SUBSURFACE WASTEWATER DISPOSAL SYSTEM APPLICATION

PROPERTY LOCATION	
Town or Plantation	PORTLAND PEAKS ISLAND
Street Subdivision Lot *	5 SARGENT ROAD (90-D LOTS 16,3)
PROPERTY OWNER'S NAME	
Last:	JOHNSON
First:	SHEPARD
Applicant's Name	
Mailing Address of Owner	5 SARGENT ROAD PEAKS ISLAND, PORTLAND ME, 04108
Daytime Tel. *	766-5640

REPLACEMENT SYSTEM VARIANCE REQUEST

SITE PLAN

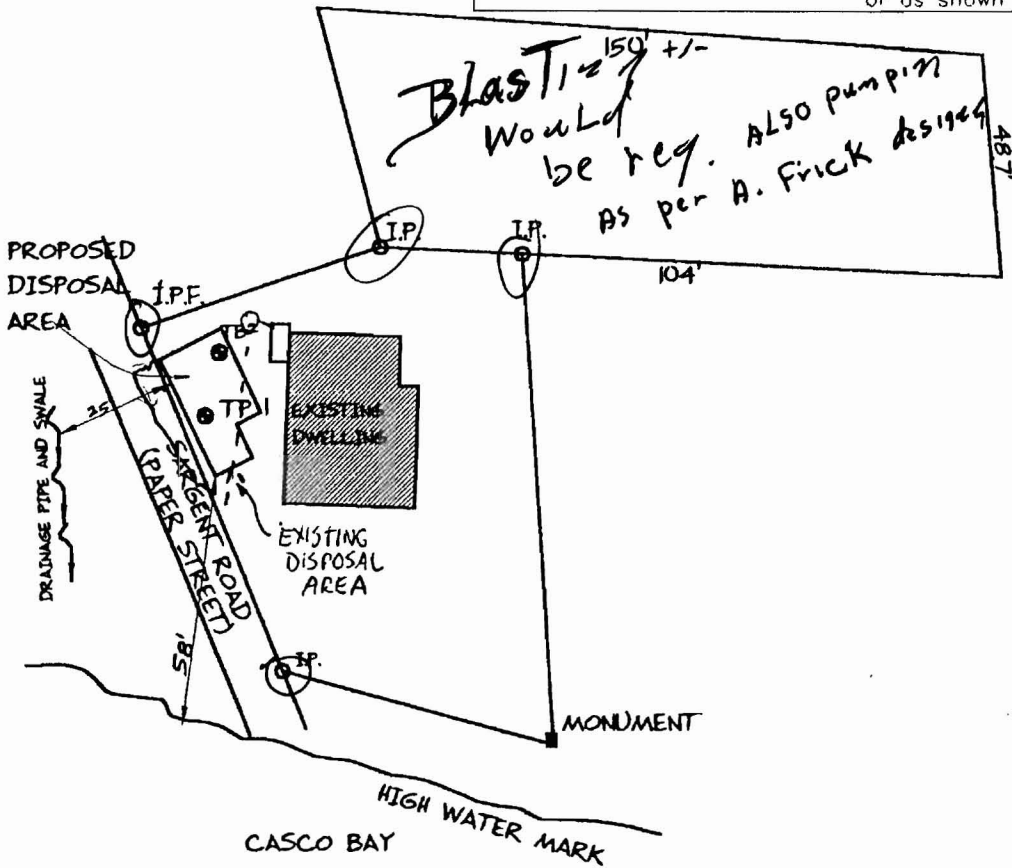
Comments: The proposed Subsurface Wastewater Disposal system is on Public Paper Street, (part) Disapproved
